PRODUCT/PROCESS CHANGE NOTICE (PCN)

PCN #: **G-0206-08** DATE: 6/17/2002
Product Affected: All square PQFP and TQFP packages
shipped in Tape and Reel

ATTACHMENT - PCN #: G-0206-08

FROM:

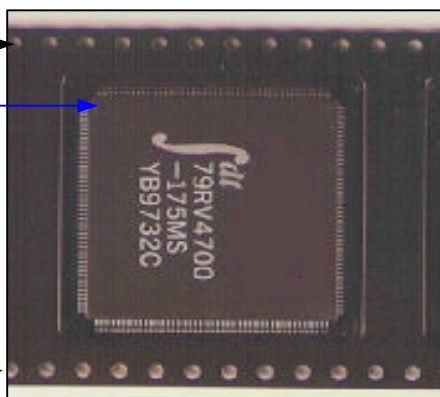
Pin 1 orientation of all square PQFP and TQFP packages shipped in Tape and Reel packaging will be changed to comply with current EIA Standards (EIA-481-2-A) requirement.

Detail of Change: This change will be implemented on all square PQFP and TQFP packages.
